**Re: Application for a Coastal Marshlands Protection Act for Howard Coffin
Park Drainage Ditch Improvements, City of Brunswick, Tidal Ditch, Glynn
County (GPS 31.150397/-81.480806),**

HOWARD COFFIN PARK DRAINAGE IMPROVEMENTS

RESPONSE TO CRD REQUEST FOR ADDITIONAL INFORMATION

Response to CRD RAI Request received via email of 4/1/2025

EXHIBIT 1B

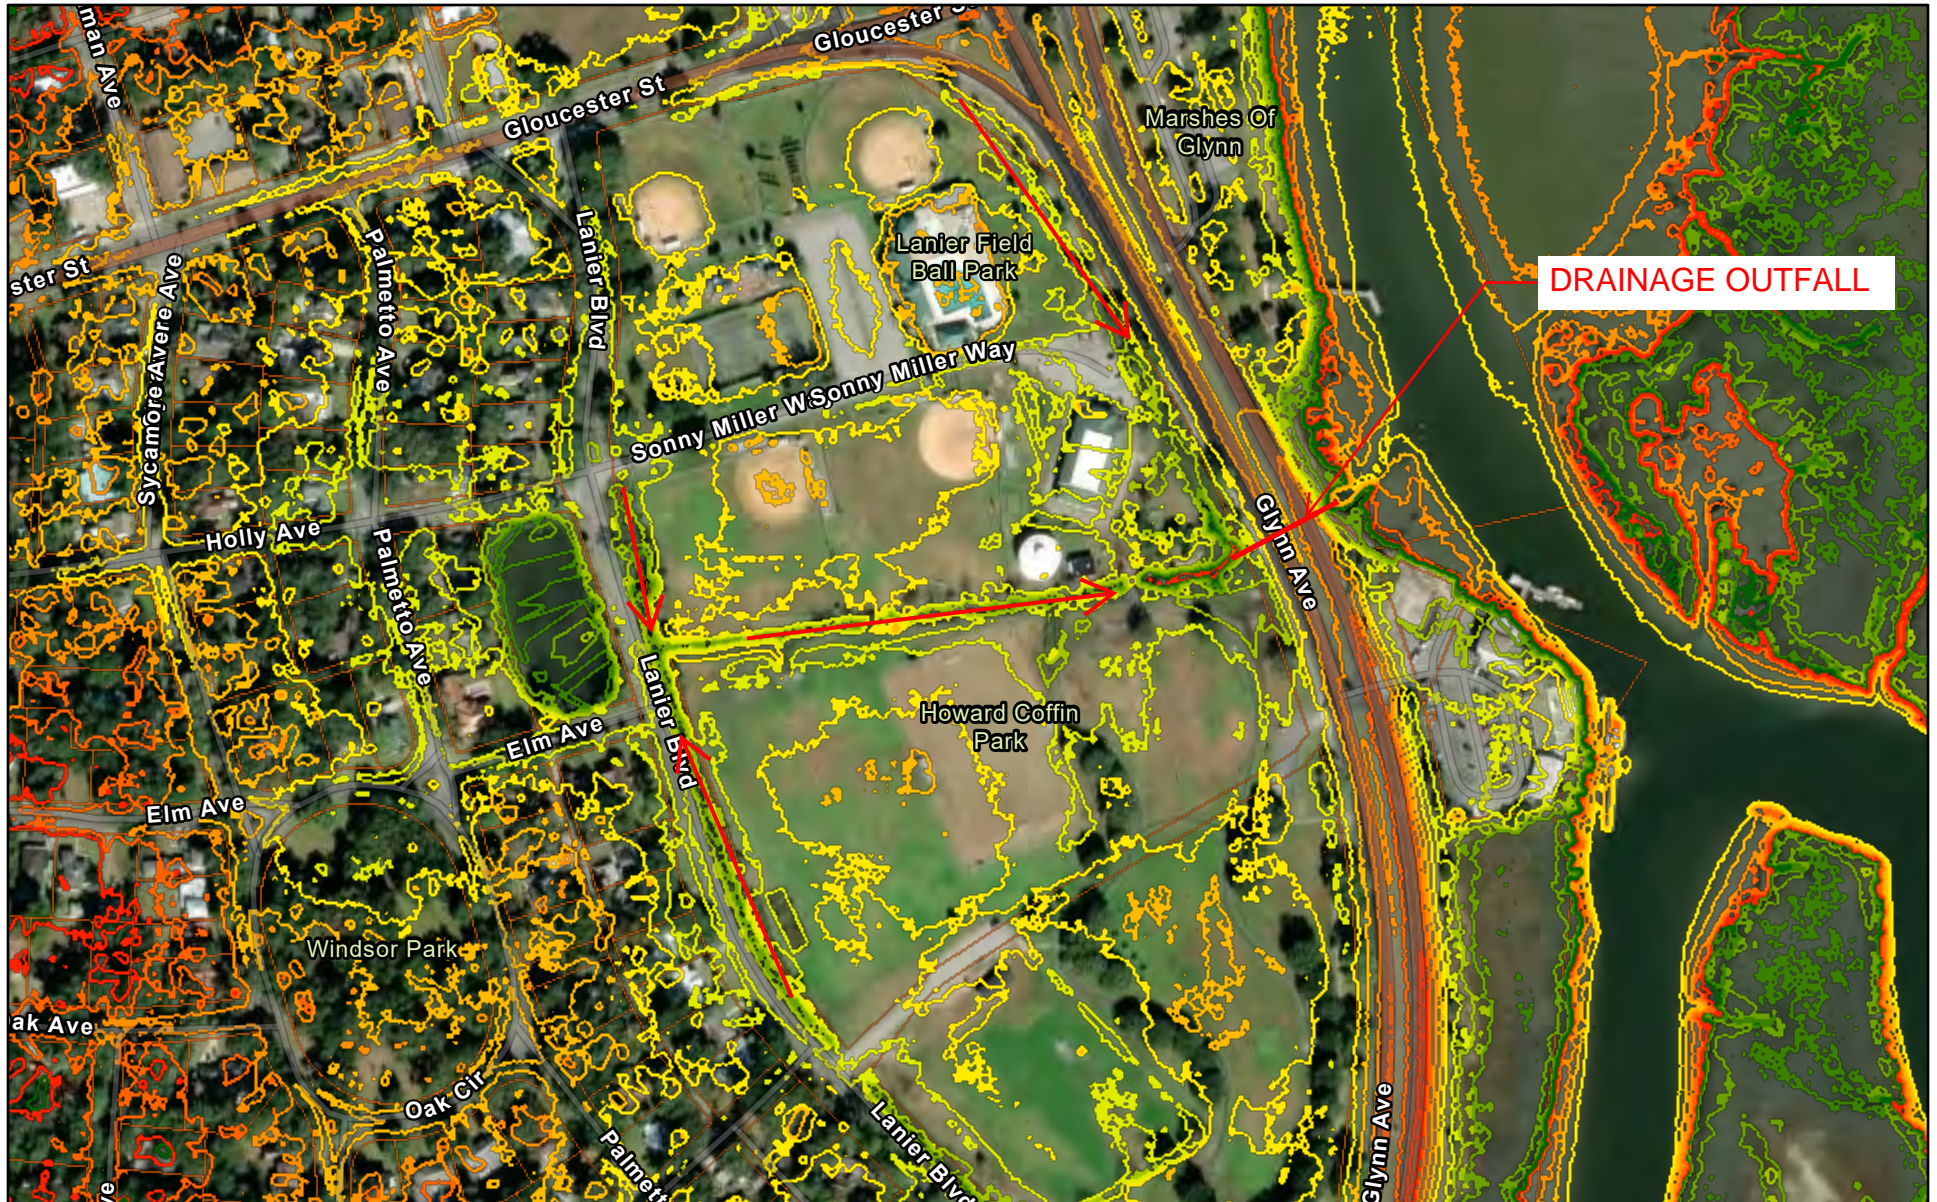
- b. Provide details on how the network of existing ditches to the north will function and drain stormwater from the surrounding basin to Clubbs creek at the terminal end of the system.

The only ditch to the north of the Howard Coffin Ditch is more of a shallow swale running adjacent to the ROW of US 17S between the ball field/pool area and the highway. This area flows to the south where it connects to the pipe crossing at the east end of the Howard Coffin ditch.

See attached Exhibit 1b showing the overflow direction.

EXHIBIT 3

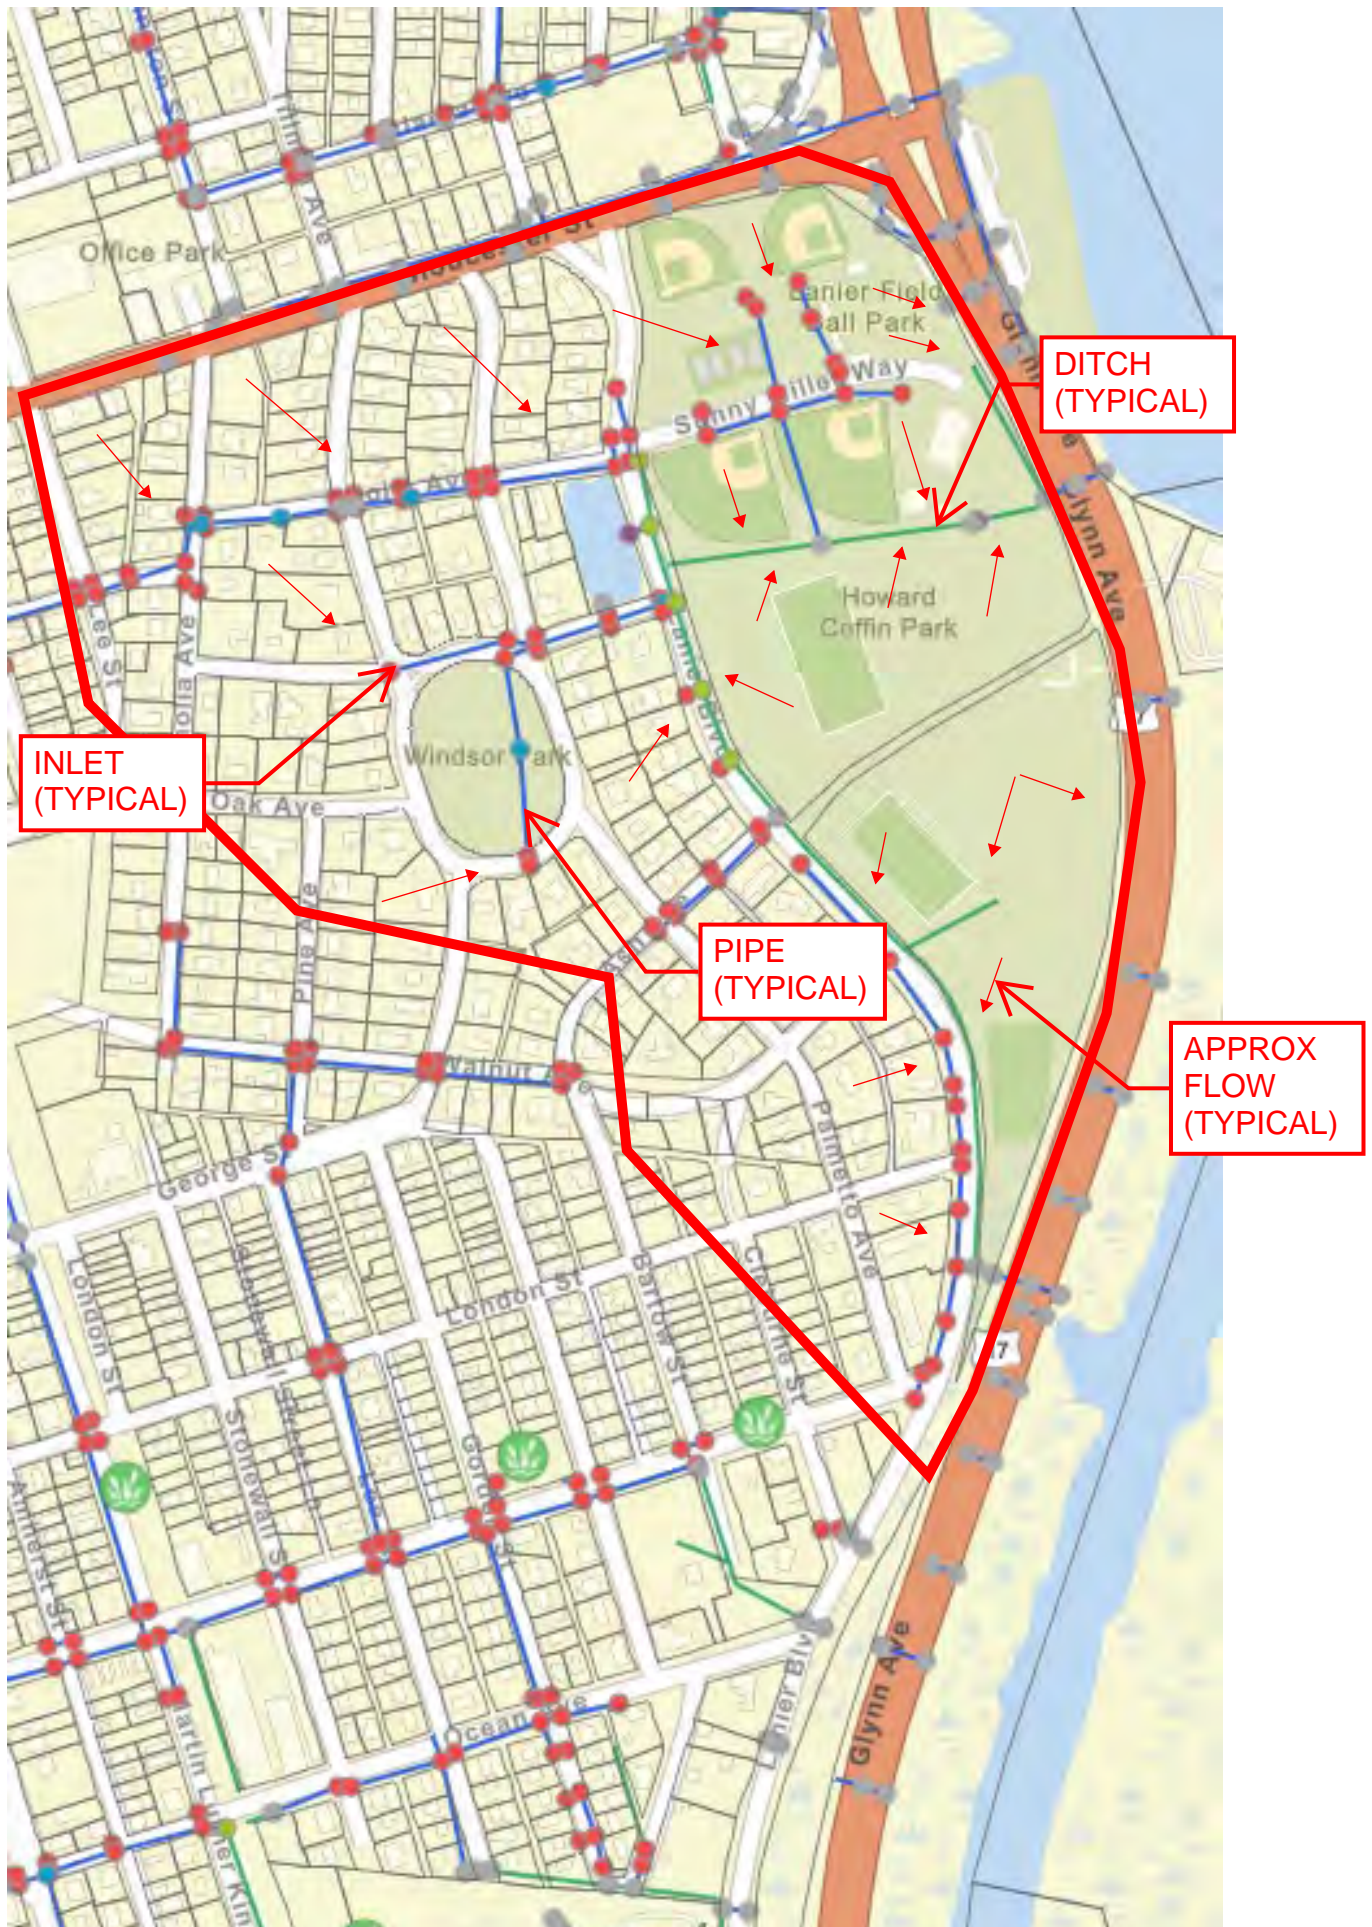
- 3. Provide schematics of all drains, pipes, elevation gradient and associated flow, drainage patterns, drainage basin area, stormwater inflows to tidal ditch and any other information pertinent to flow regimes in the system. What is the total drainage area for this project? How will areas of ponding within the drainage ditches be avoided? Please provide figures to illustrate where stormwater will be entering the ditch system.

- 3. Exhibit 3 shows a pipe on Ash Ave. This seems to be omitted from this response as well as 2a.
- 5a. I have done a pre-application site visit with the agent for the proposed living shoreline (LSL) on this end of the project area and he told me that the project area for your application would stop at the earthen road/culvert located near the middle of the east-west ditch. Please clarify what is going to be done in the area as it relates to the forthcoming LSL application.

Please see attach Exhibit 3

The approximate average elevation gradient across the site is 0.5%

The four pipes that discharge into the drainage ditch are 18”, 24”, 30” and 36” diameter. See below for the approximate flow of each pipe size with the assumption that the pipe is flowing full.

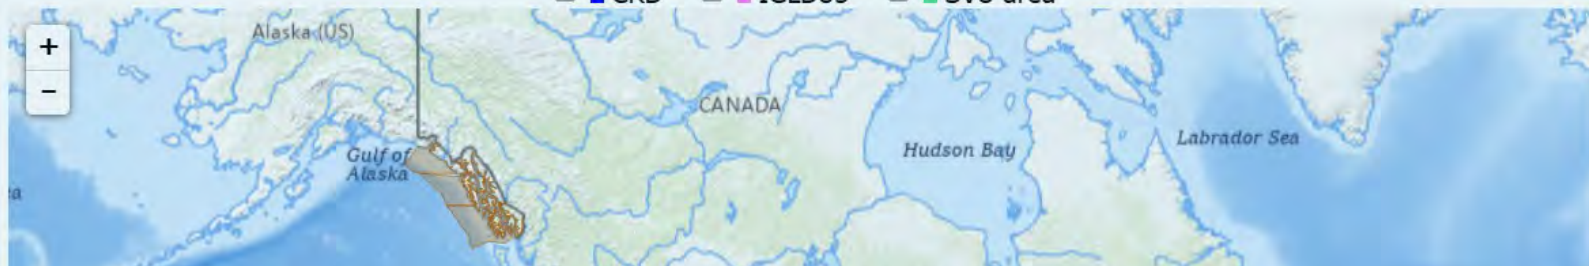
4. The cross sections are labeled with MHW and MLW measurements of MHW - 2.5ft and MLW - 4ft. Please explain the values and how they were calculated.

Please see attached exhibits.

Both the MHW and MLW values are shown even though the MLW elevation is below the actual ditch bottom. The intent was to represent the ditch being fully drained during the lower tide stages.

The values shown on the cross section were determined using the NOAA Online Vertical Datum Transformation website and the NOAA Tides and Currents website. Station 8677344 St. Simons Island, GA was used. Both sources are showing relatively the same elevations.
